AGENDA
Planning Commission Meeting
July 14, 2026 @ 5:30 PM

PROJECT: The A's Lodging Facility, Major Design Review, Sketch Plan

STAFF
REPORT: The A's, Lodging, Sketch Major Design Review, X County Road 600 (Parcel # 569916143002)

MAJOR DESIGN REVIEW - SKETCH PLAN

C3

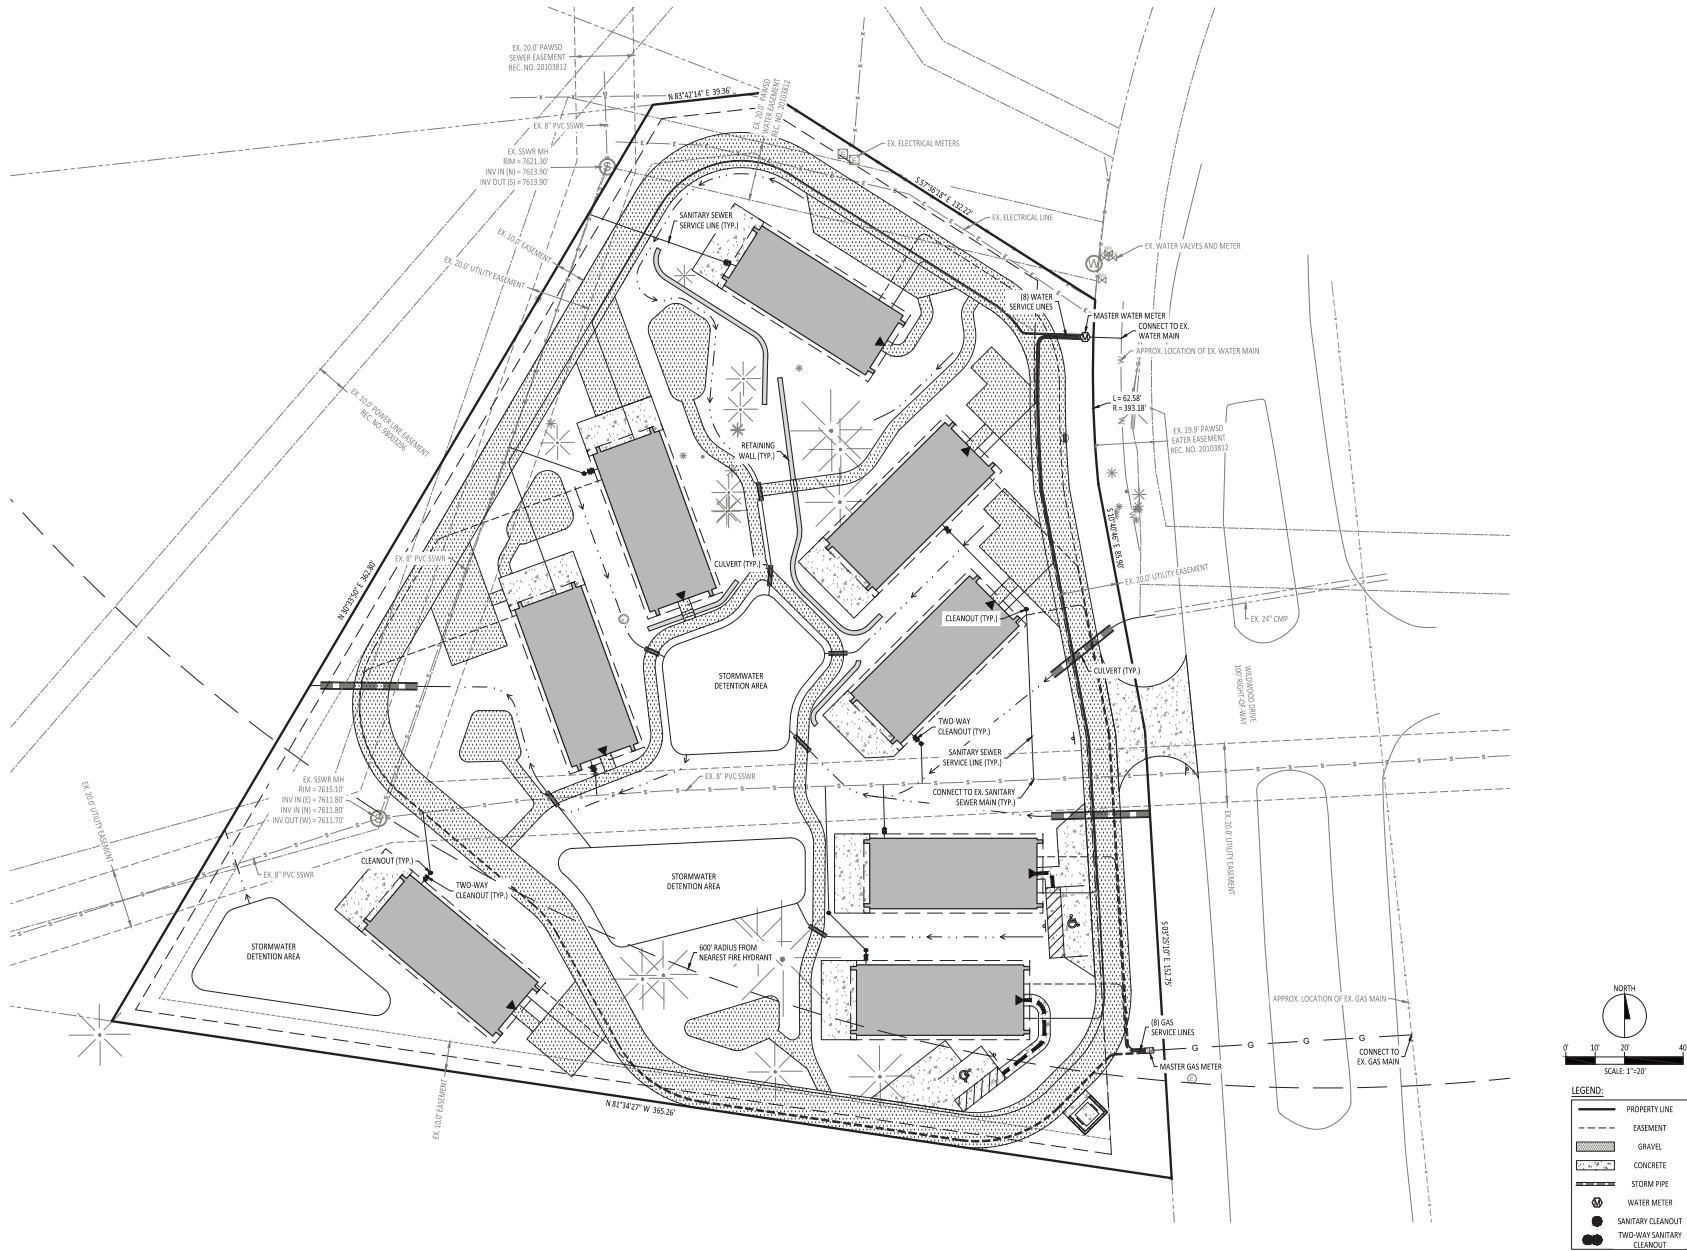
5. Applicant must install a fire hydrant on the north side of the depicted driveway loop as required by the Pagosa Springs Fire Protection District (LUDC 6.3.6) (PSFPD Review)

Our only comment is that a fire hydrant is needed for the project.

- **Vacation Renters Parking** – The sketch plans show two parking spaces per cabin. There do not appear to be any other parking spaces shown. Vacation renters are known for showing up with more vehicles and more people than what the accommodations allow. Vacation renters show up with trailers, boats, RV's and a multitude of oversize vehicles. Parking is not allowed on Wildwood Dr, the private entrance road. How will this cabin development address this issue?

BUILDING ELEVATIONS

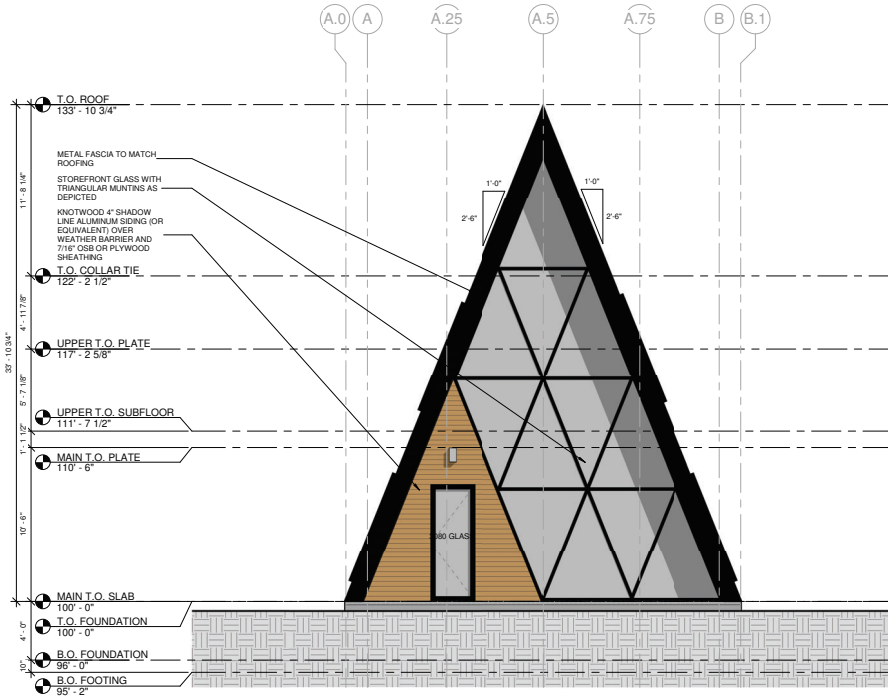
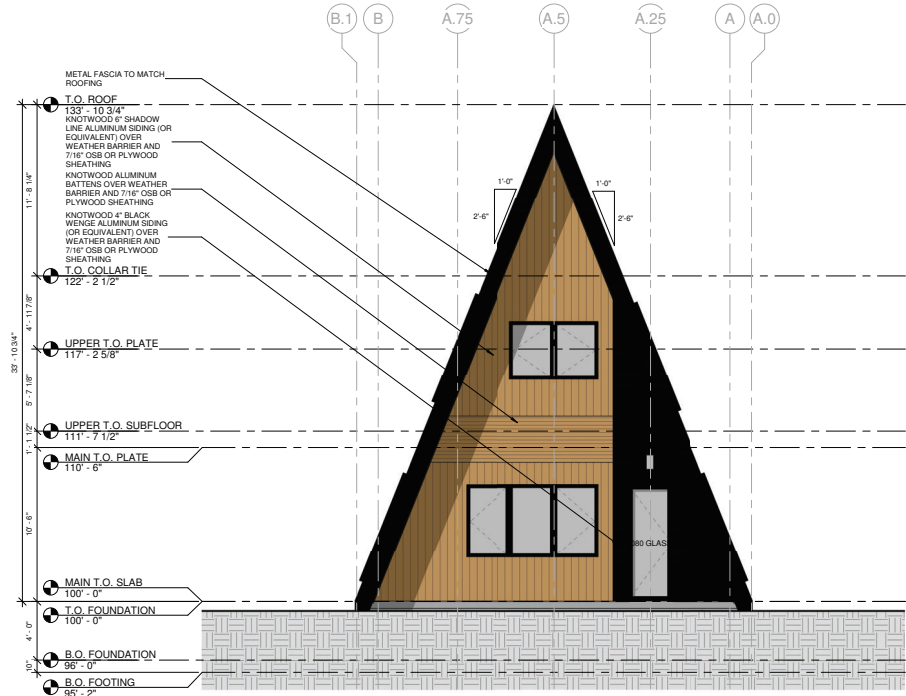
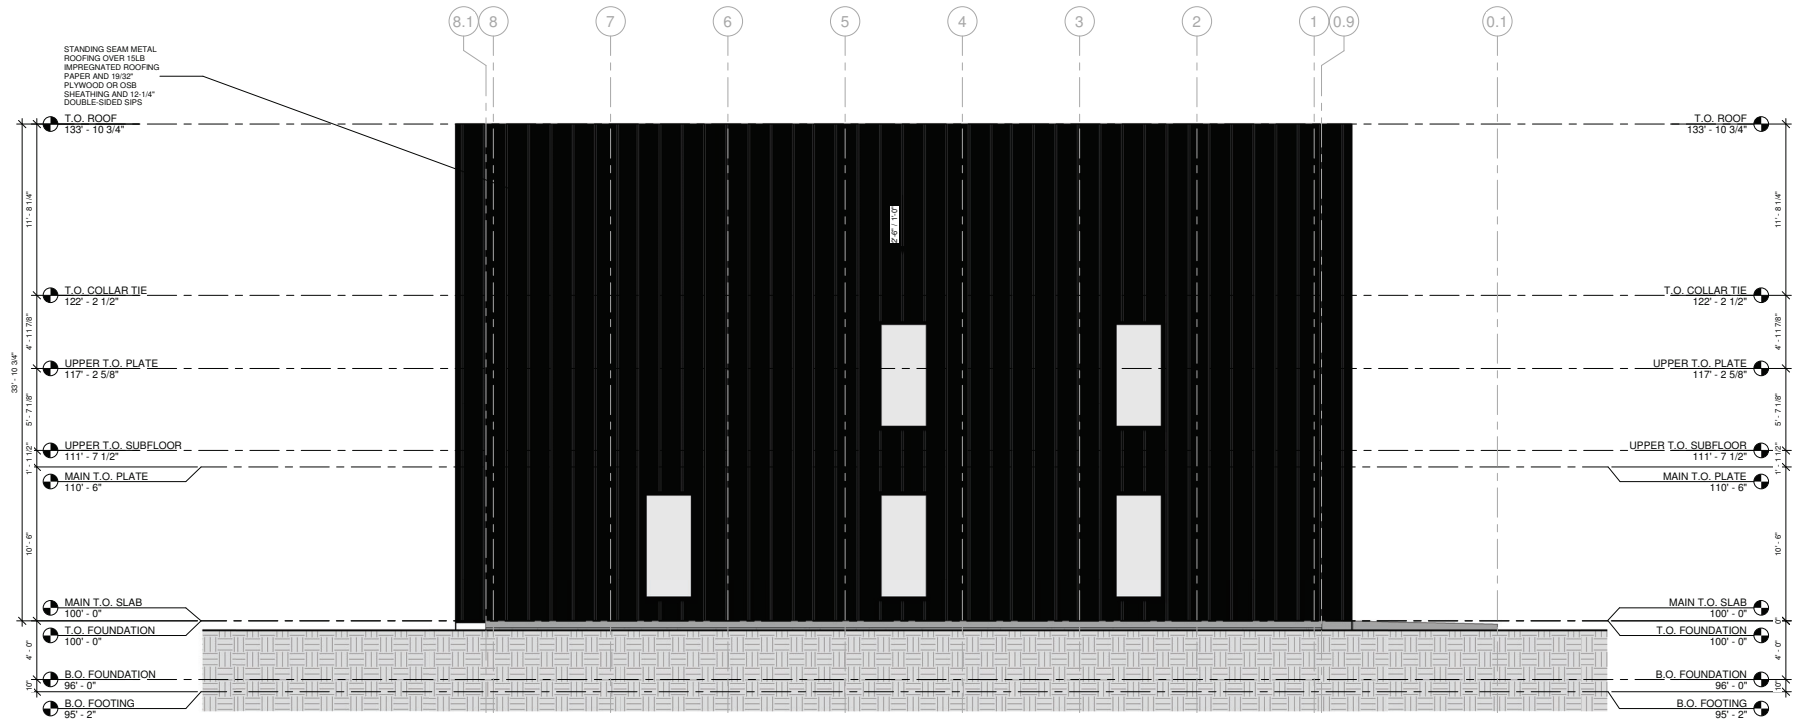
In reviewing the planned location of the 8 vacation rental cabins, it appears that no consideration was given to local climatic conditions. Buildings face a variety of directions with some degree of entrance/exit overhangs but blowing snow will be problematic. The A-Frame roof style must be evaluated for winter snows. Snow sliding from the extremely high roofs will accumulate at the ground level and pile up against the roofing material. It has no place to go. These roofs can generate 3 – 6 feet of snow accumulation against what is spec'ed to be standing seam metal roofing material. Depending on the intensity of the winter weather, snow can sit against this roofing for as many as three months...often freezing and thawing. Roofing and building damage can be the result. Window locations may also need to be evaluated. If snow is allowed to accumulate against window frames and glass, damages may occur. If heating is planned to be natural gas, gas meters must be located to avoid burial by snow from the roofs.
